ADDENDUM NUMBER ONE
to the
PROJECT SPECIFICATIONS
and
CONTRACT DOCUMENTS
for
FY 2015 Pavement Preservation Project
Project # 2157810-8930-90036

DATE OF ADDENDUM: **May 30, 2014**

EXHIBIT "A" FY 2015 PAVEMENT PRESERVATION PROJECT

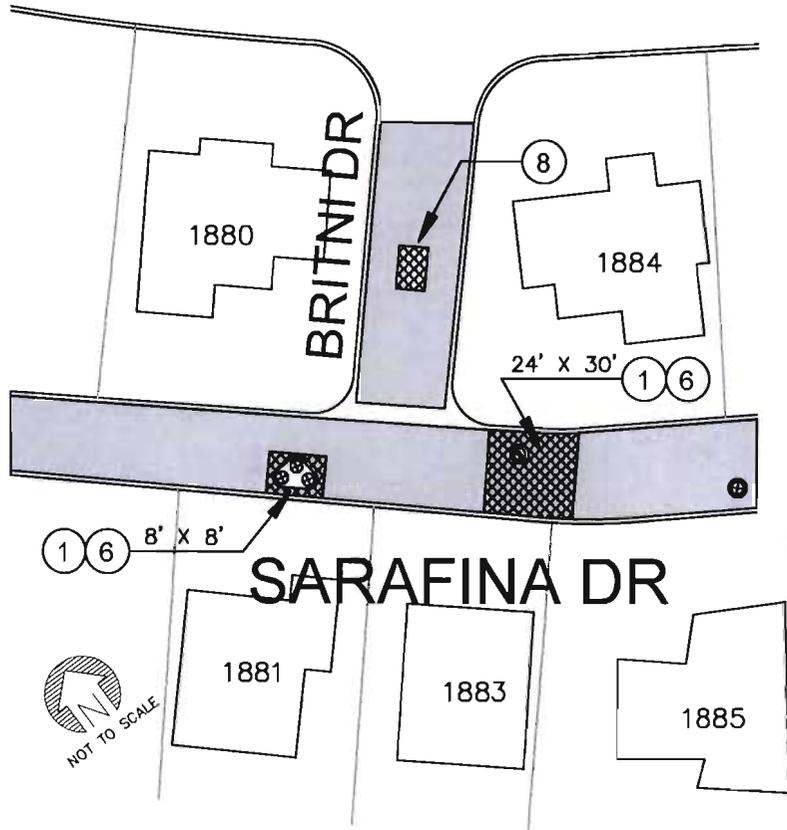
PAVEMENT REPAIRS CONSTRUCTION NOTE: ADDED BY ADDENDUM

EXISTING SADDLE TYPE WATER VAULT TO BE REMOVED. SAWCUT 18" AROUND EXISTING WATER VAULT AND EXCAVATE TO DEPTH OF VAULT. REMOVE THE VAULT INTACT. DELIVER AND OFFLOAD UNDAMAGED VAULT AT THE COP WATER OPERATIONS FACILITY ON SUNDOG RANCH ROAD.

RESTORE EXCAVATION WITH COMPACTED AGGREGATE BASE MATERIAL PLACED IN LIFTS. PAVE BACK PER PAVEMENT REPAIR TYPE 1.

EXISTING VAULT IS APPROXIMATELY 9' X 6' BY 6' DEEP. PROTECT IN PLACE EXISTING WATER MAIN AT BOTTOM OF VAULT.

The Contractor shall remove the existing water vault on Britni Drive per Exhibit "A".

Payment shall be at the lump sum cost to include all sawcutting, excavation, removal of the existing water vault in one, undamaged unit, backfill excavation with aggregate base course placed in compacted lifts, paved back with 4" thick asphalt concrete pavement in two compacted lifts flush with the adjoining pavement, and all incidental work necessary to complete the work in place. Payment shall include delivering and off-loading the vault at the City Water Operations Facility on Sundog Ranch Road.
